MIL-P-70505 (AR)
AMENDMENT 4
26 December 1992
SUPERSEDING
AMENDMENT 3
3 April 1989

MILITARY SPECIFICATION

PROJECTILE, 155MM: XM864
PROPELLANT GRAIN

FIGURE 1. Machined propellant stick

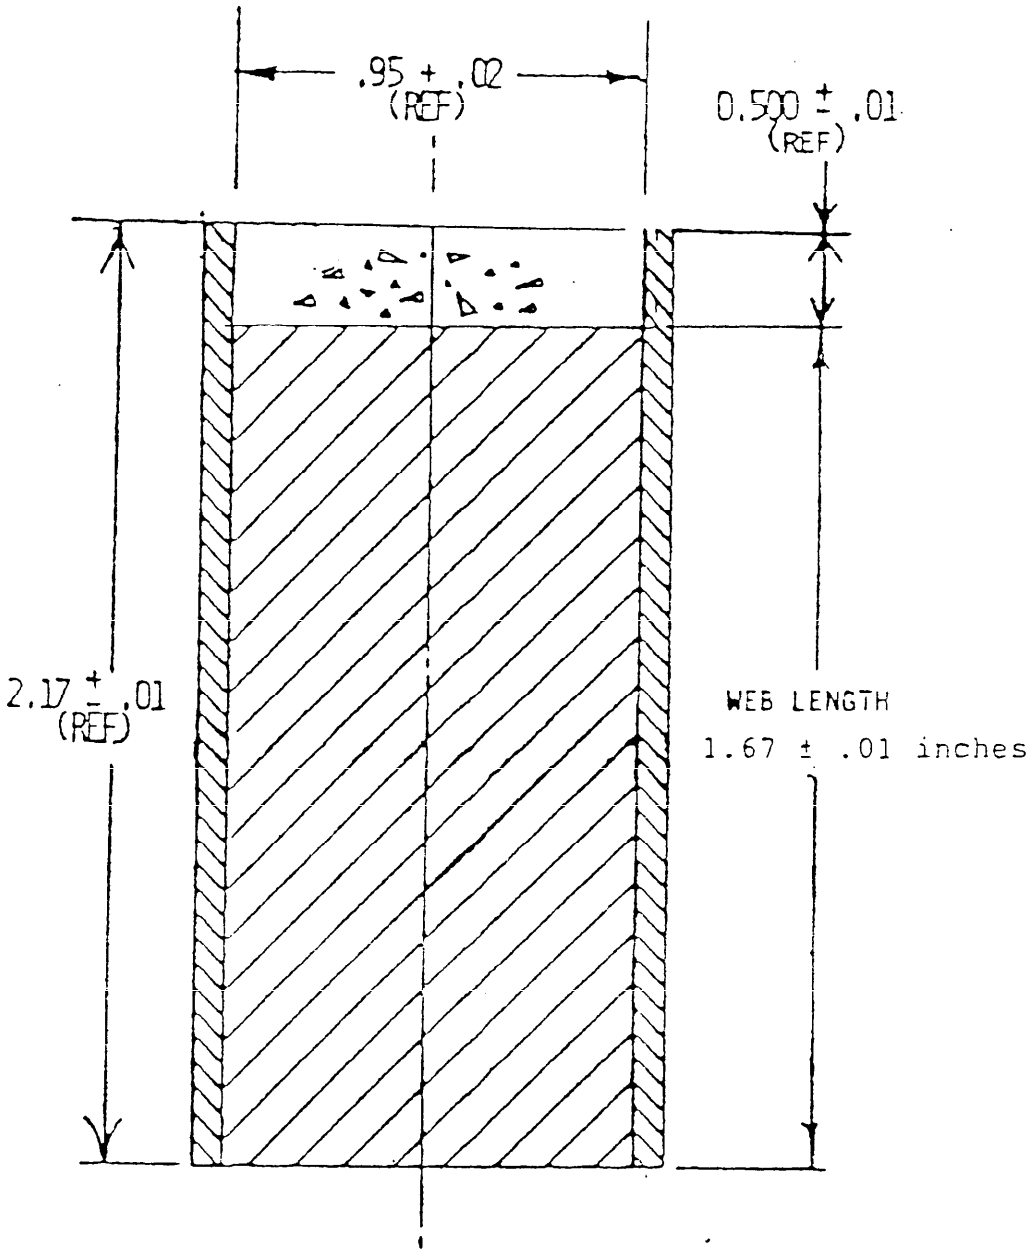
i. Chuck the propellant sticks lightly in a lathe. Machine three (3) each propellant sticks from x-ray accepted areas of the propellant sticks in accordance with Figure 1.

FIGURE 2 - Assembly Instructions

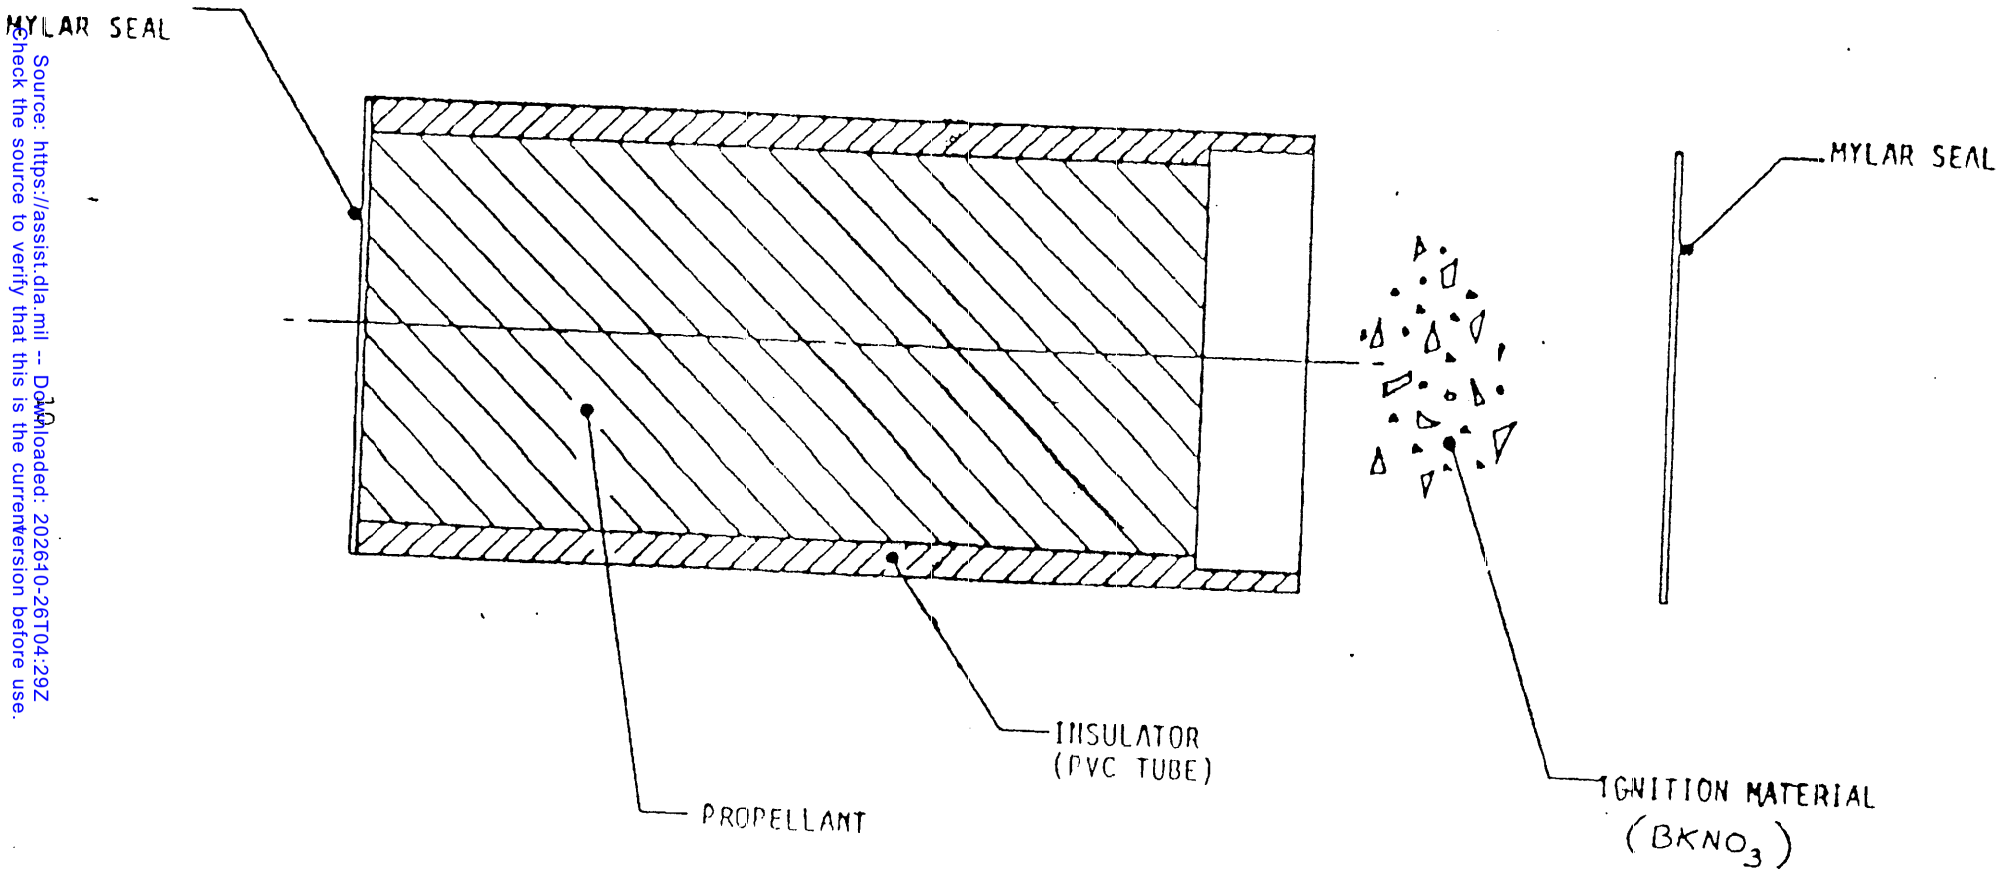
j. Place a mylar seal onto the end opposite of the bored propellant stick in accordance with Figure 2.

m. Place a mylar seal over the IP-10-$BKNO_3$ powder, $BKNO_3$ 2L pellets, and seal the end of the grain shut in accordance with Figure 2.

FIGURE 3: Initiator is redundant (M-100) electric matches

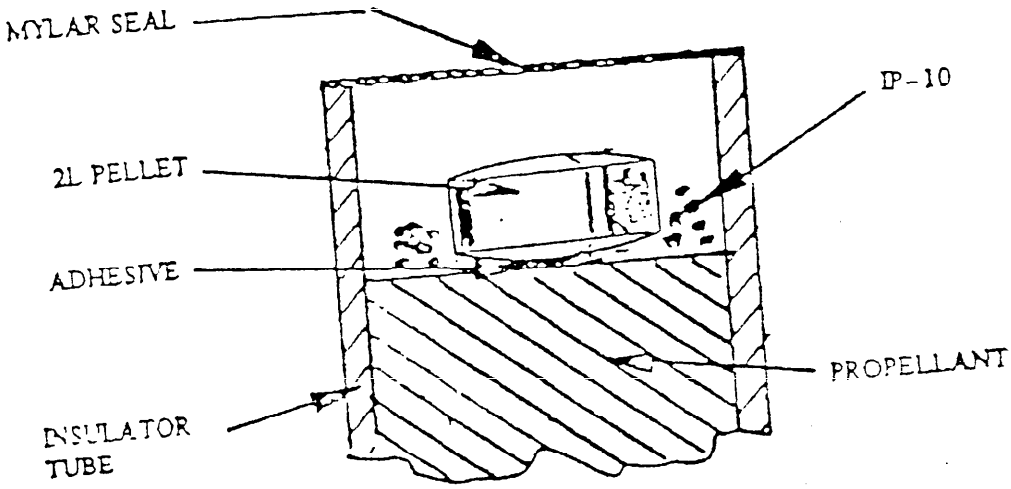
l. Place a two (2) gram quantity of IP-10-$BKNO_3$ powder around the adhered 2L pellet and seal the propellant stick with a mylar seal in accordance with Figure 3.
